**AGENDA FOR REGULAR MEETING  
VILLAGE OF TINLEY PARK  
PLAN COMMISSION  
March 19, 2015 – 7:30 P.M.  
Council Chambers  
Village Hall - 16250 South Oak Park Avenue**

**ITEM #1**                      **EDENBRIDGE APARTMENTS (ED SCHULZ, A&R KATZ, PETITIONER) – 18100 AND 18102 S. 66<sup>th</sup> COURT – MINOR CHANGES TO THE EDINBRIDGE PLANNED UNIT DEVELOPMENT INCLUDING SITE PLAN APPROVAL FOR A PARKING LOT EXPANSION AND LANDSCAPE IMPROVEMENTS** (Assigned Commissioners Reidy and Mahoney)

# PLAN COMMISSION

*(Medium Density Residential  
District, Edenbridge Planned Unit  
Development)*

## PHASING DIAGRAM

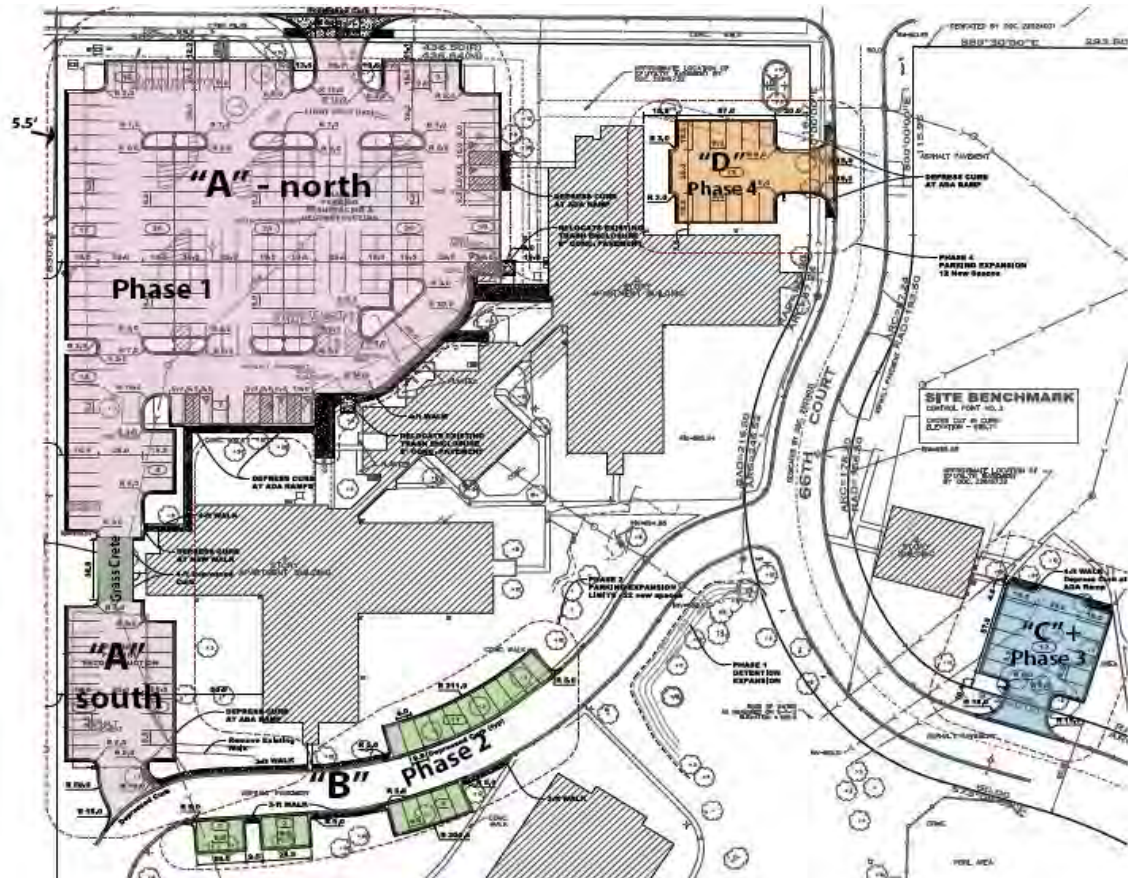
**Open Item #1:** *The Applicant must identify a timeline for phasing the parking lot improvements.*

**APPLICANT WILL BEGIN PHASE 1 THIS CONSTRUCTION SEASON; PHASE TWO WILL INCLUDE REMAINING IMPROVEMENTS TO BE COMPLETED THE FOLLOWING YEAR.**

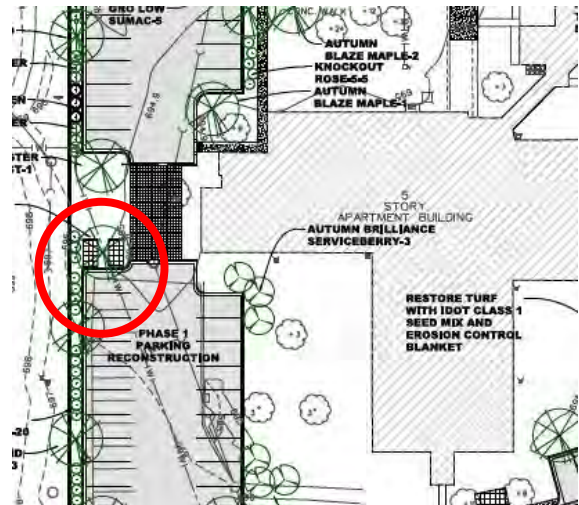
The off-street parking proposed along the private drive (Area “B”) also addresses a life safety concern expressed

**APPLICANT HAS AGREED NOT TO CONSTRUCT PARKING AREA “P”:**

LANDSCAPE  
PLAN

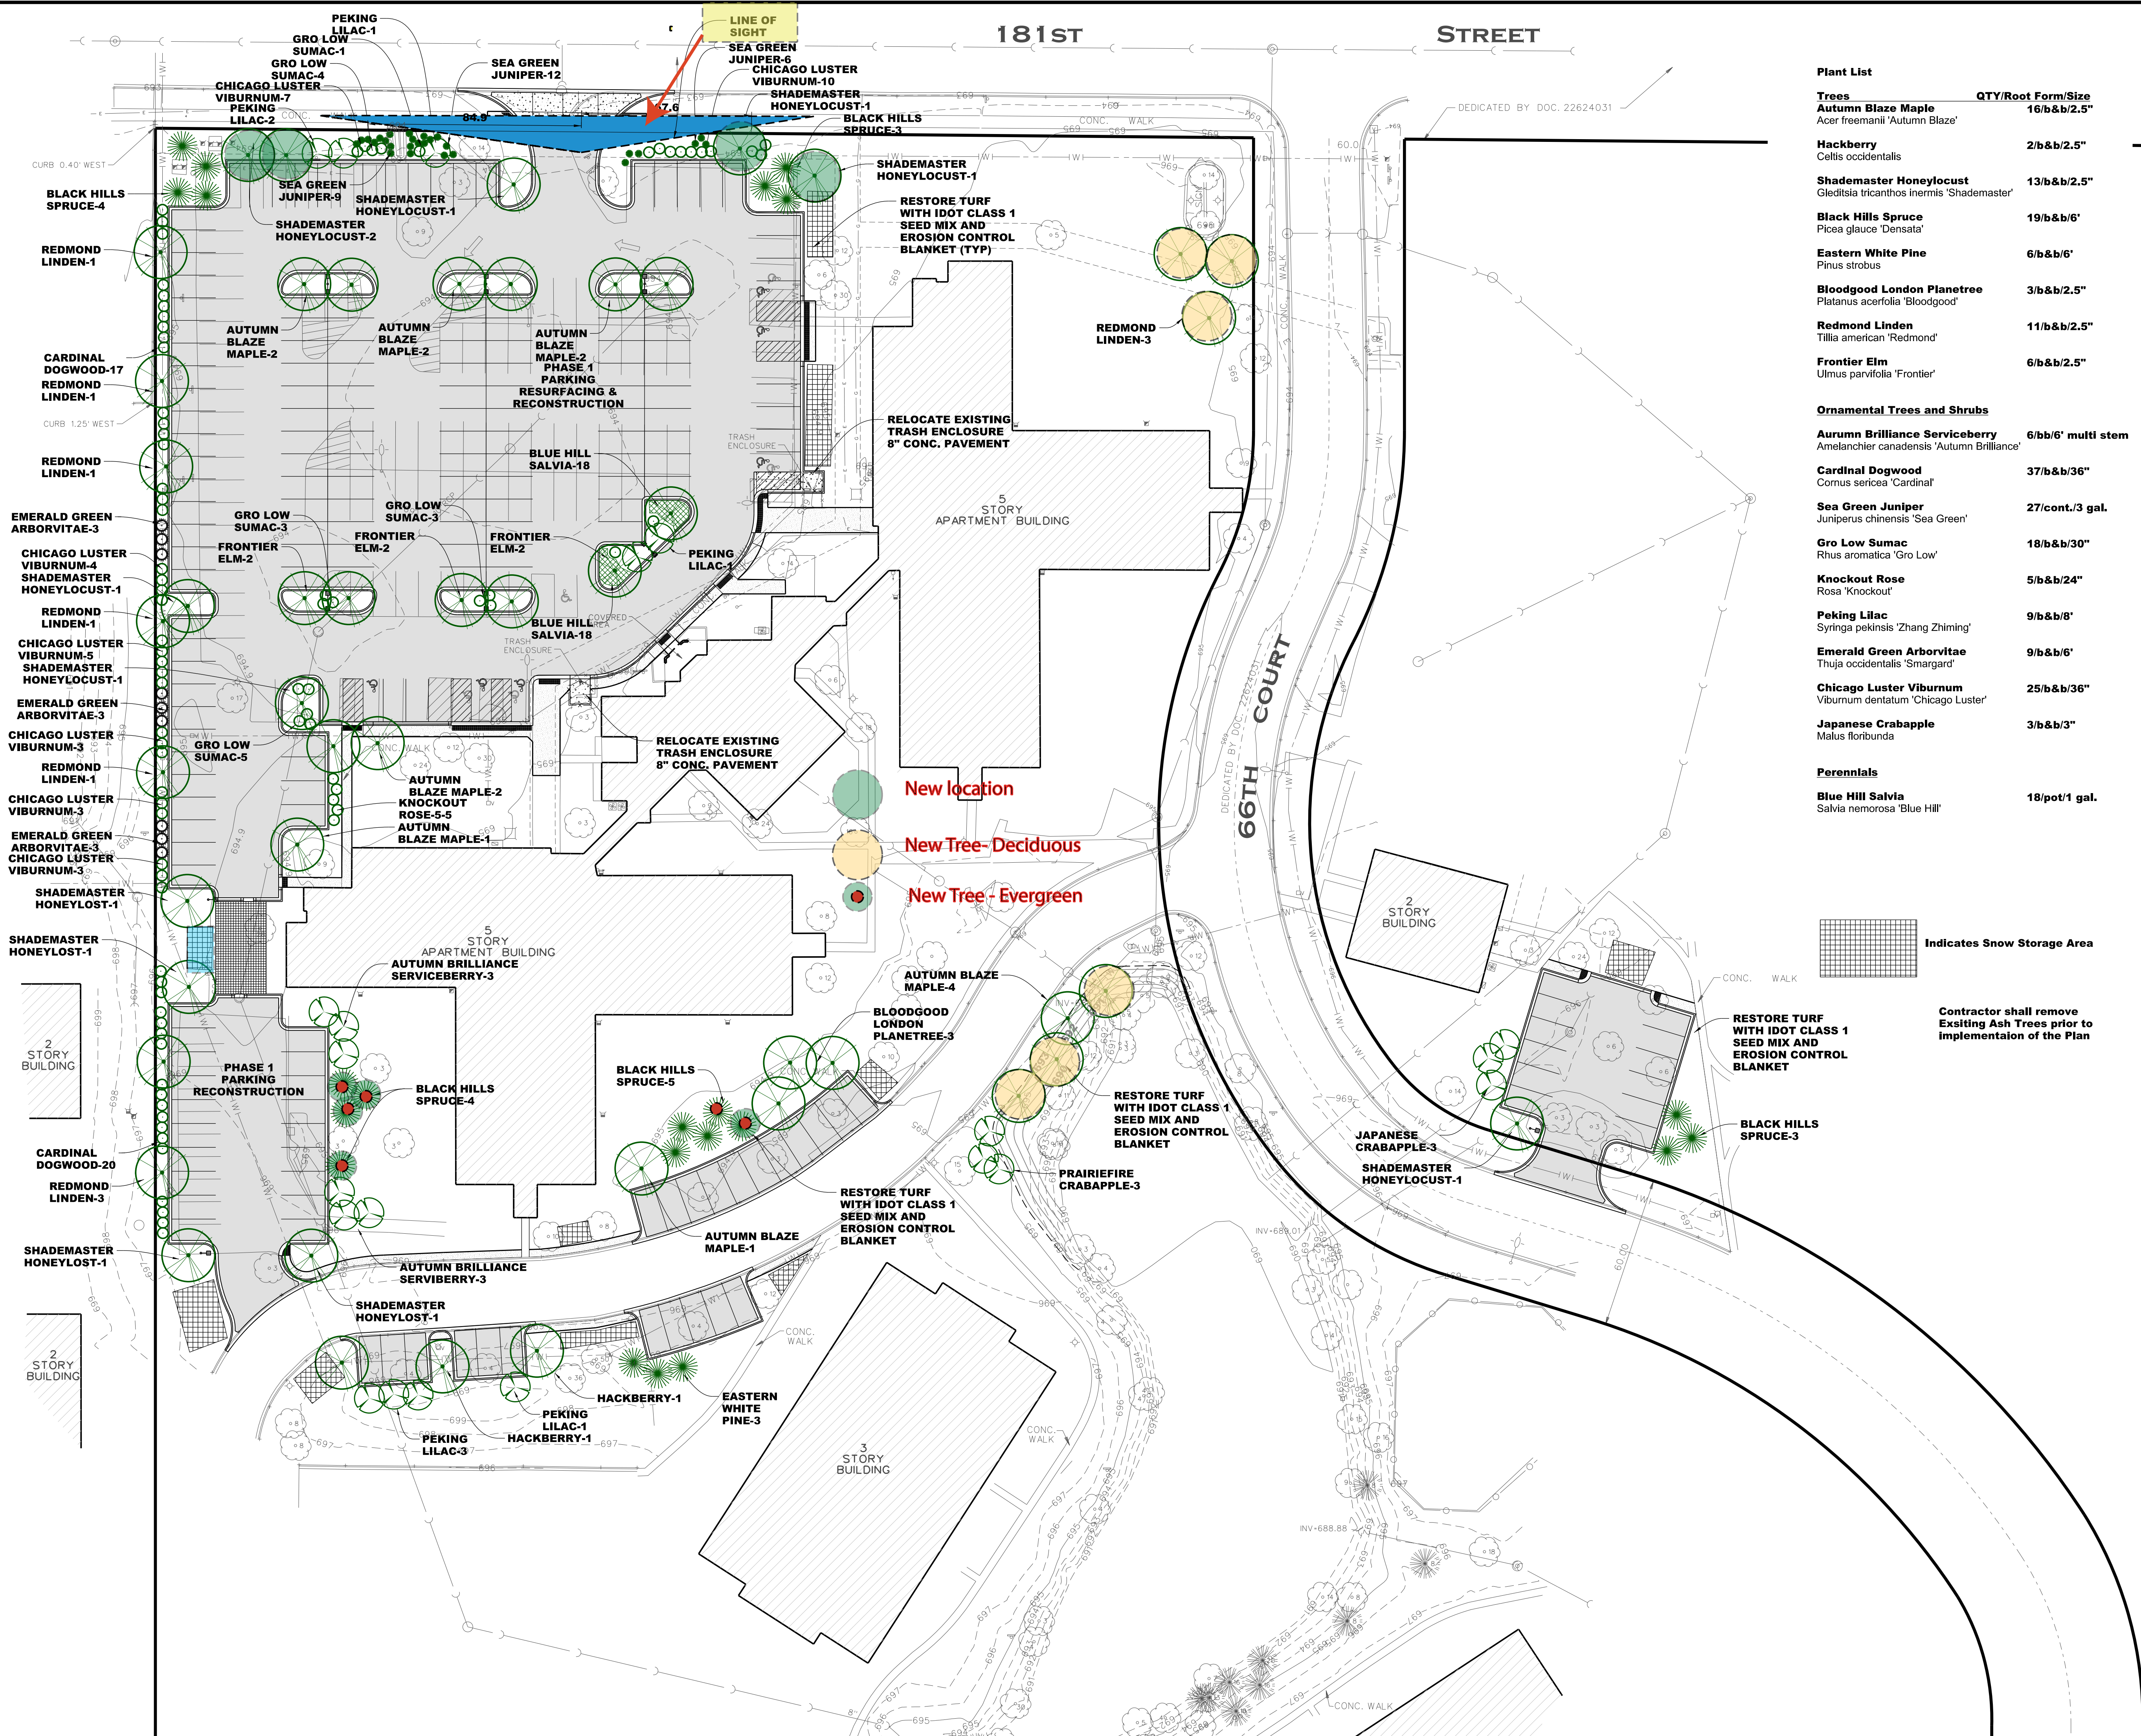
In light of the limited parking for this property, Staff requested a snow removal plan to ensure there were adequate (non-parking) areas for the piling of snow. The cross hatch pattern on the Landscape Plan indicates areas for snow storage. There are some designations that are too close to plant material and are a concern for their impact on the plant's survivability. Staff will work with the Applicant to identify alternate locations and seeks concurrence from the Plan Commission that this is a concern.

**Open Item #4: Location of snow storage areas.****APPLICANT WILL REMOVE SNOW STORAGE AREAS THAT CONFLICT WITH PLANTING AREAS OR ENCROACH VISION TRIANGLE AT ACCESS ON 181<sup>ST</sup> STREET.****LANDSCAPE**

The site has mature landscaping that has provided some screening of the existing parking lots; however, there are no landscape islands currently in the parking lot for Fulton Commons "A". With the proposed improvements, eight (8) landscape islands will be added to the reconfigured parking lot. This will help to mitigate the expanse of asphalt in this area and provide shade to the parking lot.

Currently there is minimal landscaping along the 181<sup>st</sup> Street frontage or the west property line. With the proposed improvements to Edenbridge, additional landscaping will be planted along 181<sup>st</sup> Street and the west property line which will include a significant amount of evergreen material. This will help to screen the parking lot and headlight glare of those using the Fulton Commons parking lot. The additional landscaping along 181<sup>st</sup> Street will soften the streetscape in this area and enhance the entryway into the senior facility. Evergreen material has been added to provide year round screening. Landscaping has also been proposed for areas "B", "C", and "D" that will be phased in with the associated parking lot improvements.

“... motion to grant **Landscape Plan** Approval, consistent with plans dated 03/13/2015).”

BY	REVISION DESCRIPTION	DATE
RLS	Revised per Robinson Engineering review	07-21-2014
RLS	Additional Topographic Information	08-13-2014
RLS	Revised per parking stall dimension requirements	01-15-2015
SMR	Add Grasscrete and show snow storage locations	02-18-2015
RLS	Remove Phase 4 and revise Landscaping	03-13-2015
